**Re: Rapiscan AIT System Radiation Survey Reporting**

**R-0646-1 Addendum  
(Documentation Errors)**

Product Name	Secure 1000SP (Single Pose)
Serial Number	S51023009
Radiation Emission Measurement	Radiation Survey Dated: 12/04/2010
RSO Initials

**3. Inspection Zone Boundary Radiation Measurement: Survey Table. 3**

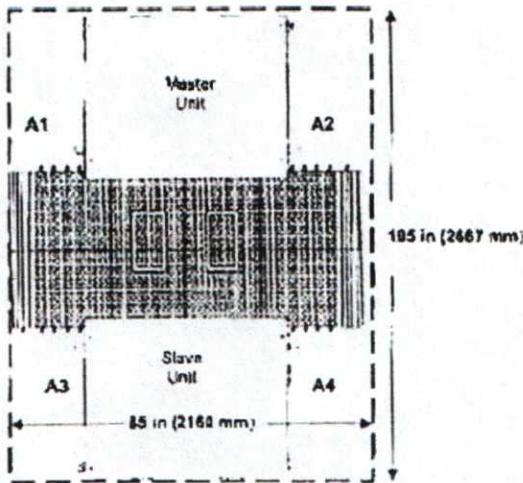
1. TABLE 3: Incorrect presentation of data in Column 6 for Dose Equivalent. Indicated value is .57 uRem. The correct value should be 1.8 uRem.
2. Technician did not print his name on survey report.

RSO will address issue with technician to ensure error is not repeated.

The corrected data indicates this system was operating within expected parameters. No re-survey is required for this system.
